**SOMERSET COUNTY  
NOTICE OF ADDENDUM**

**“Former Villa Maria Property Demolition, 641 Somerset Street, North Plainfield,  
Somerset County, New Jersey, Contract No. 19020”**

**ADDENDUM NO.1**

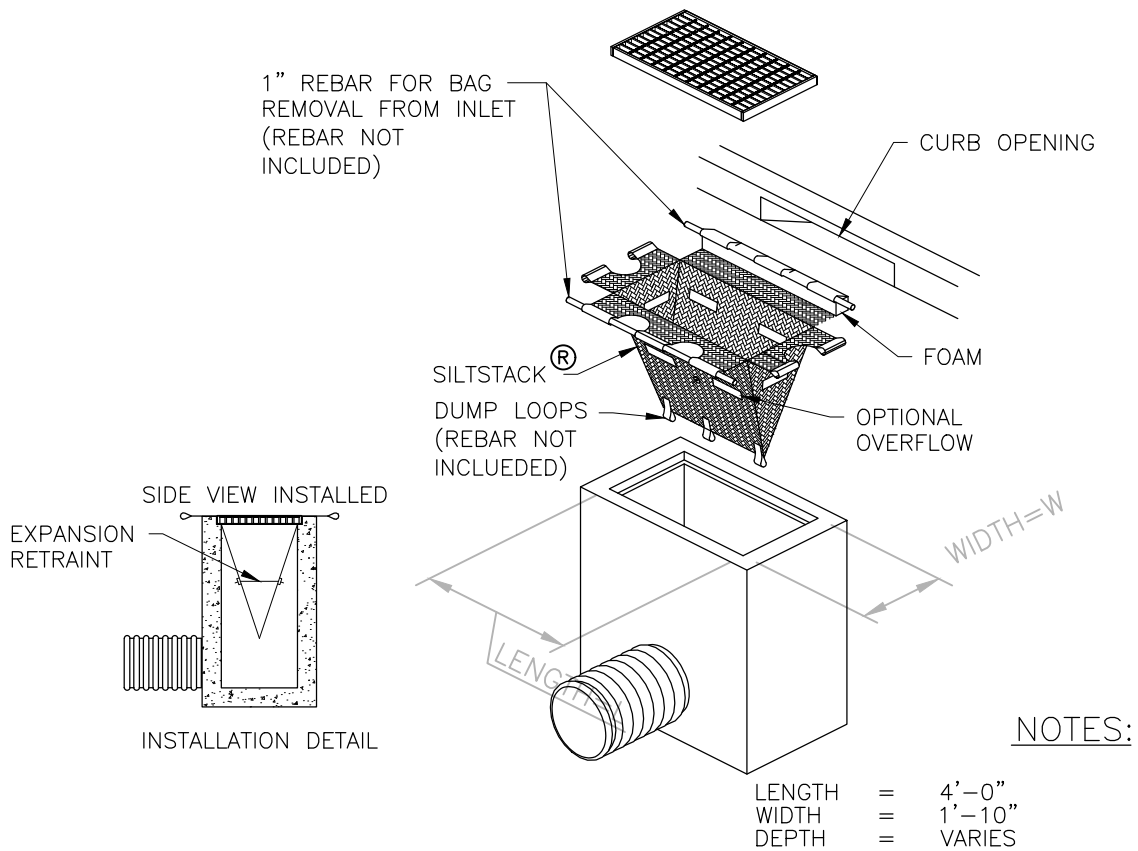
- Item 01: On plan sheet 3 - 4” Topsoiling changed to 5” Topsoiling.
- Item 02: On plan sheet 3 - Stabilized Construction Access added at the paved drive off Grove Street.
- Item 03: On plan sheet 3 - Limit of Disturbance expanded to include all tree removals and utility pole removals.
- Item 04: On plan sheet 4 - 4” Topsoil, Seed and Mulch changed to 5” Topsoil, Seed and Mulch.
- Item 05: On plan sheet 5 - “Existing Inlet Filter Protection, Type 2” detail added.
- Item 06: On plan sheet 5 - “Seed Mixture Type G” table added.
- Item 07: January 9, 2020 Pre-bid meeting minutes with Questions and Answers.
